HIGHLAND CITY DEVELOPMENT ADMINISTRATION BOARD AGENDA

DEVELOPMENT ADMINISTRATION BOARD AGENDA REPORT ITEM #2

DATE: April 11, 2024
TO: Development Administration Board
FROM: Rob Patterson, City Attorney / Planning & Zoning Administrator
SUBJECT: **Final Plat Approval:** Foxwood Estates
TYPE: **LAND USE (ADMINISTRATIVE)**

Foxwood Estates Subdivision

Sheet 2 of 2 Sheets

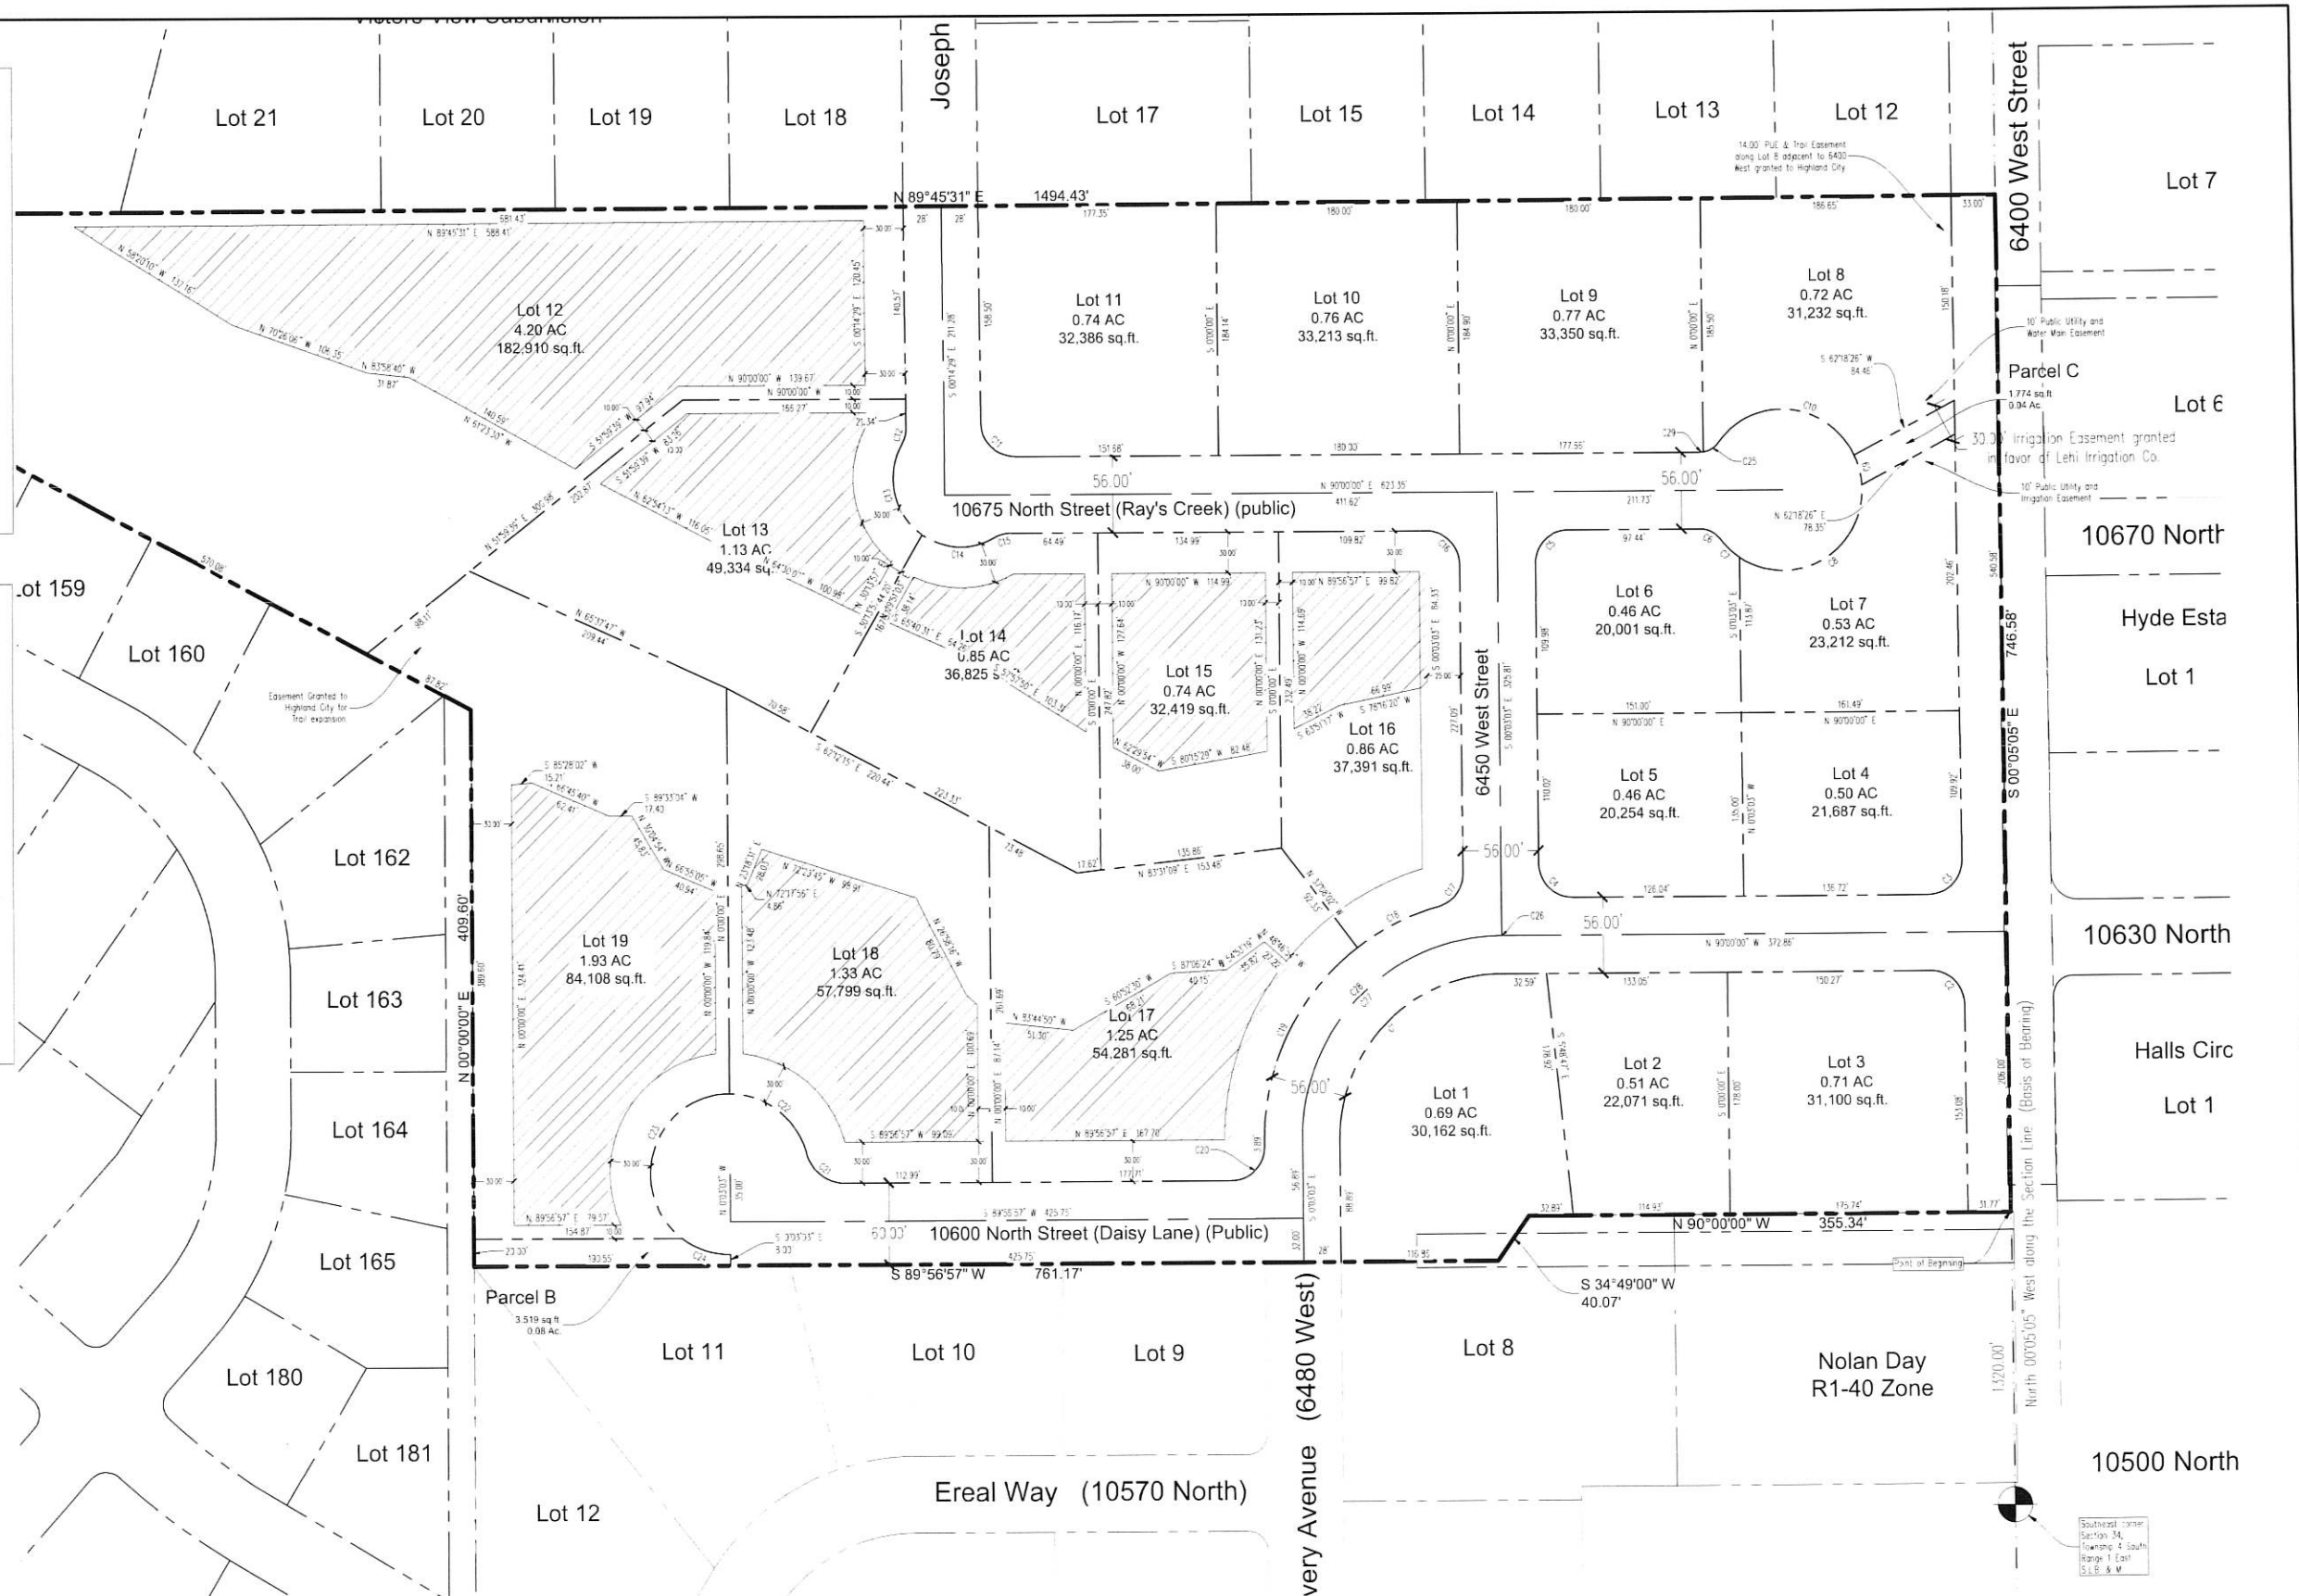
- i. Reply: **Note has been added on both sheets.**
- ii. **Response:** **This comment is closed.**
- b. New Comment: **Please make the same revisions/corrections to plat notes, cross sections, and typical lot utility easement/setbacks as per sheet 1.**

25. Show all lots on sheet 2.

Sheet No.
C - 6

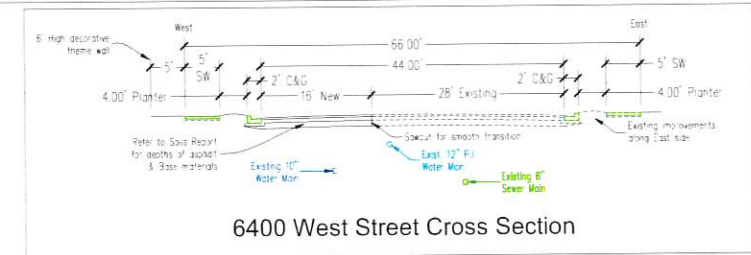
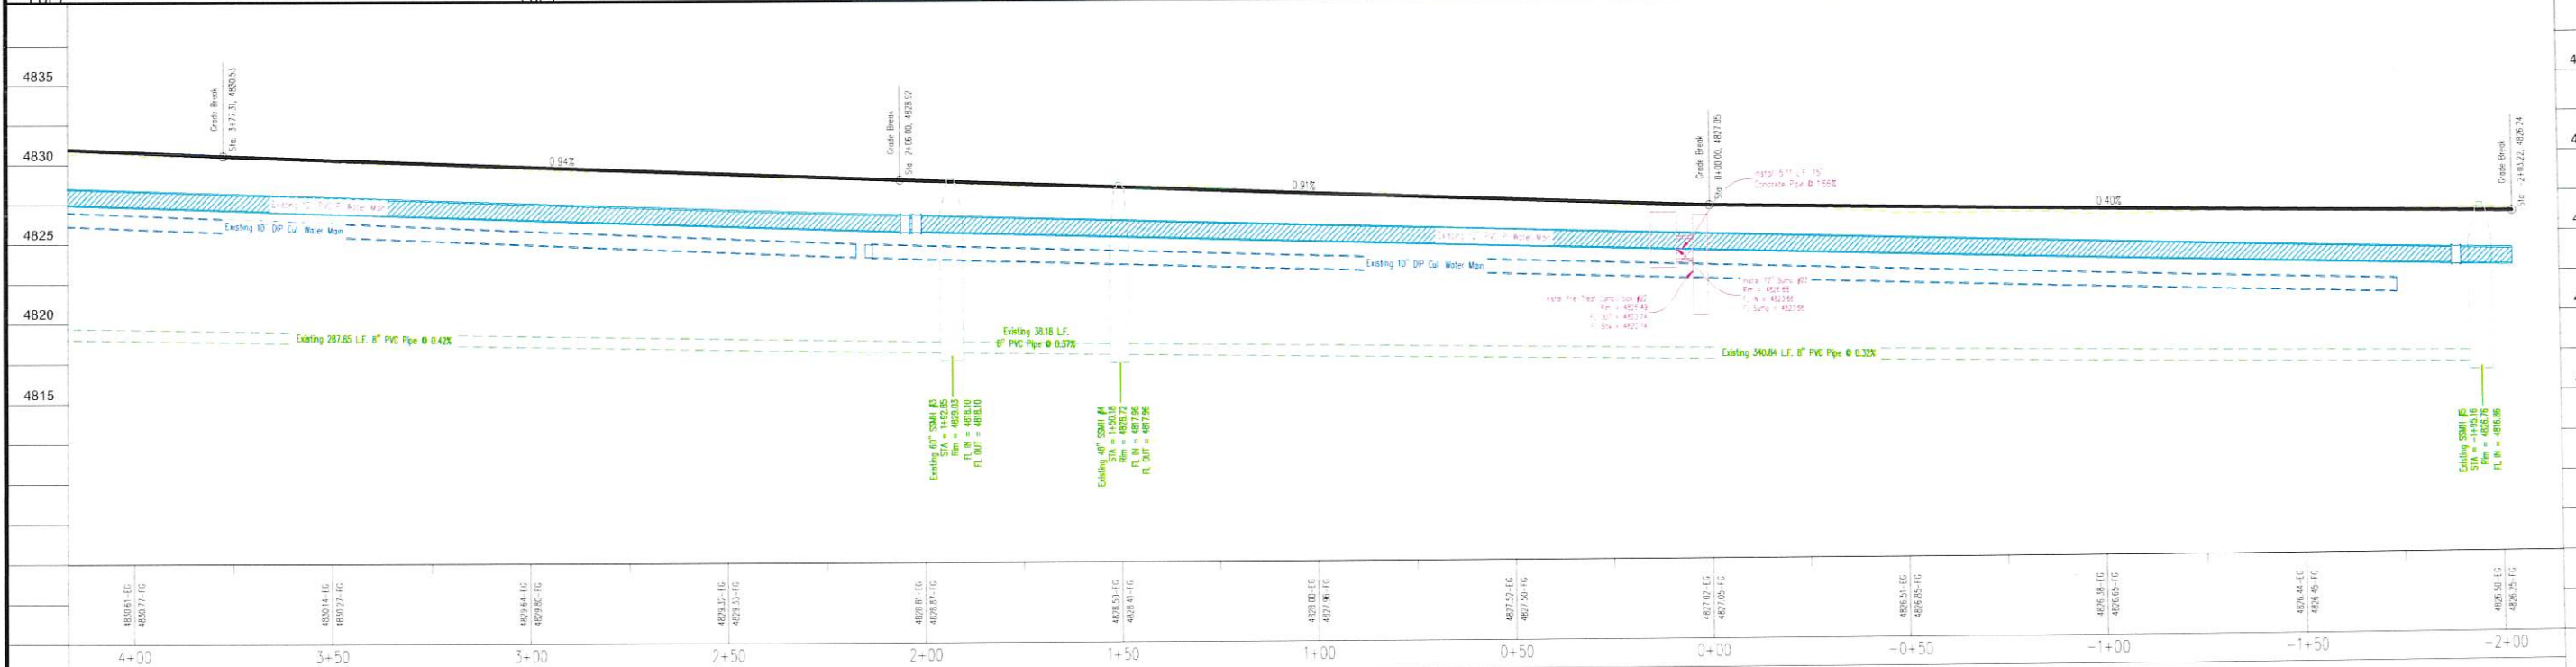
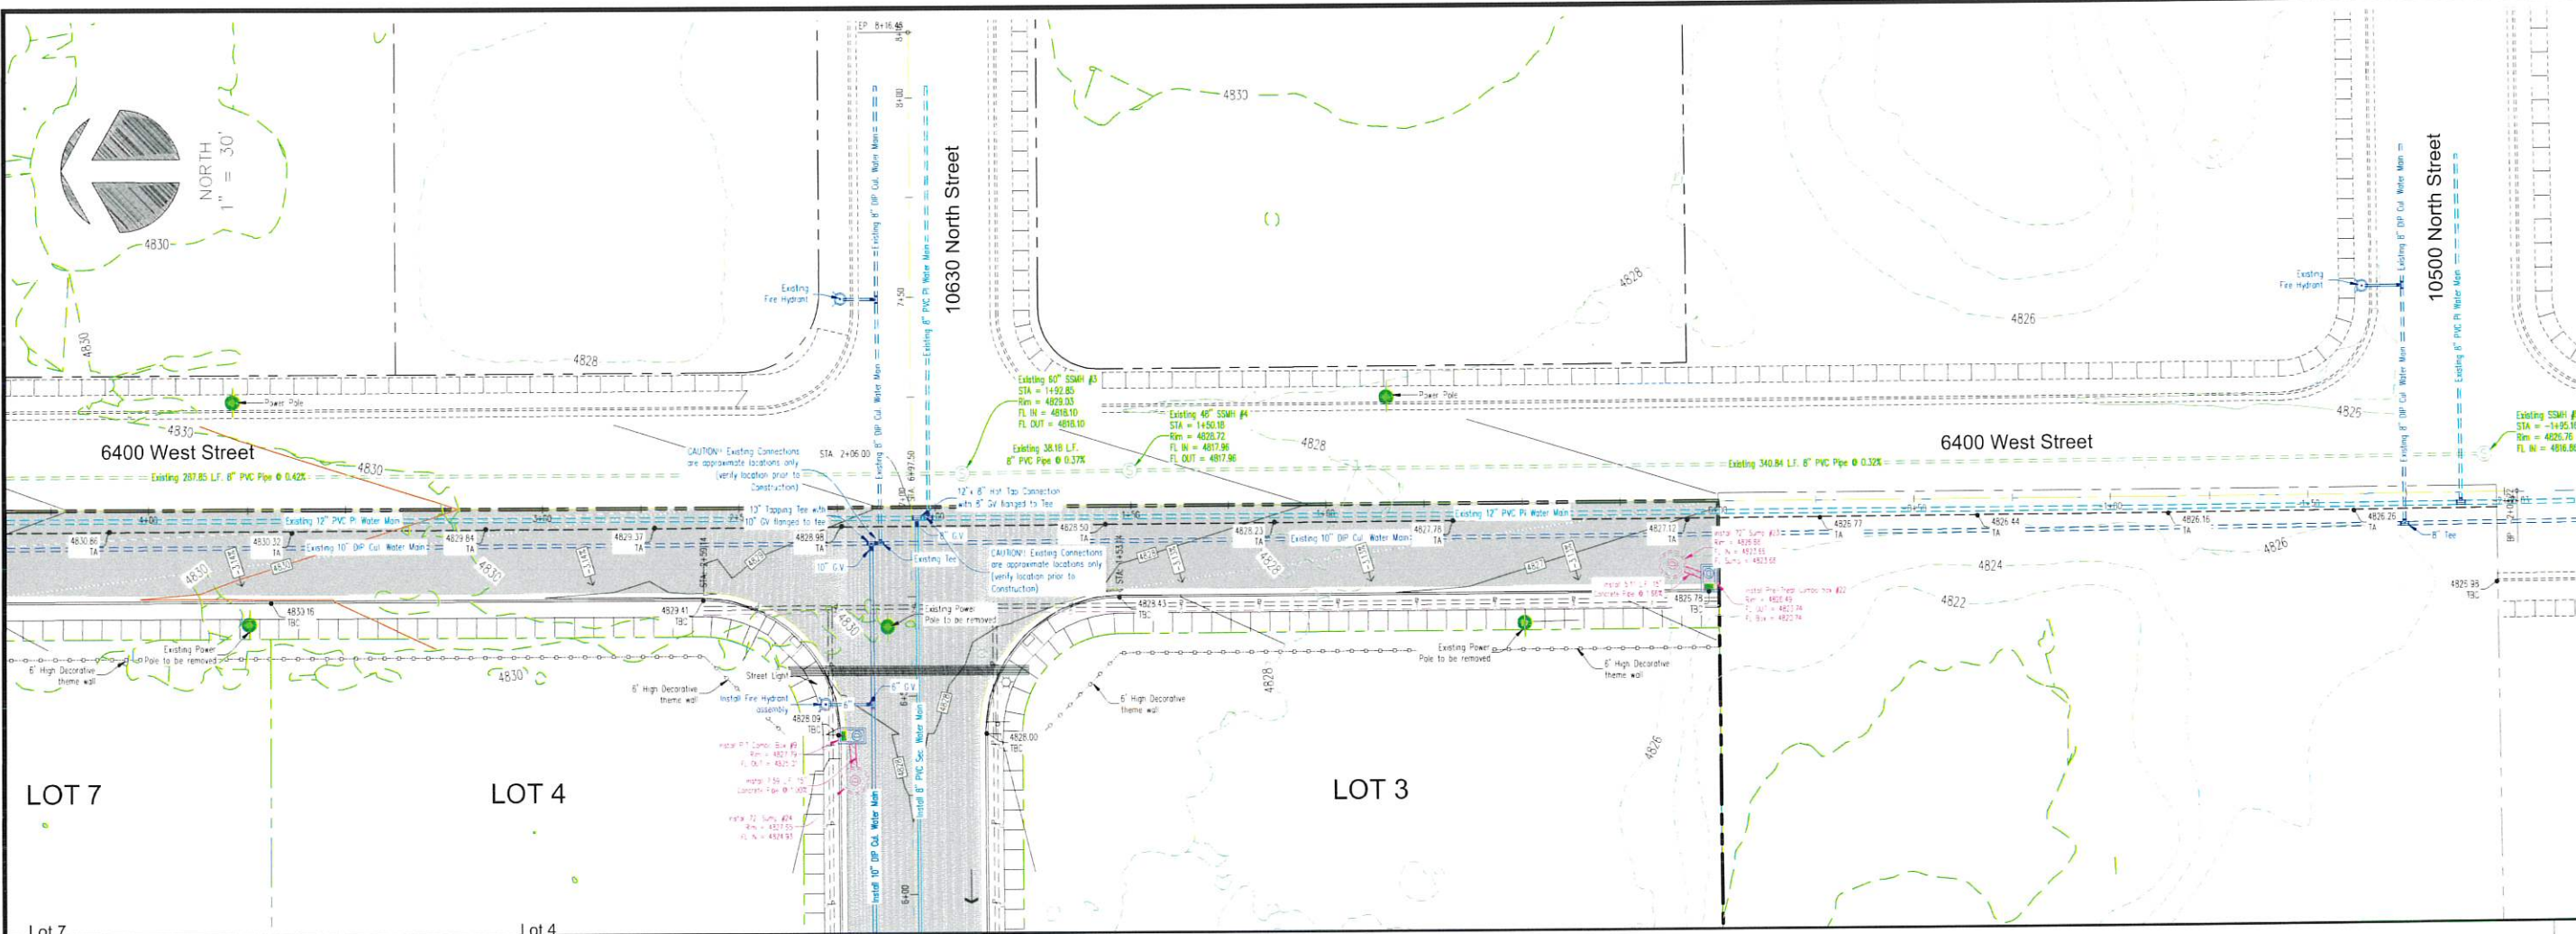
37. Verify all mains meet 4.02-B (DIP) or standard drawings DW-04.

- a. Response: **Revised.**
 - b. Reply: **This comment is closed.**
42. Add Highland City conduit banks in 2 locations, at the intersection near lot 197 (lot 4?) and Lot 3 as well as at the intersection near lot 17 and lot 1 per standard drawing U-02.
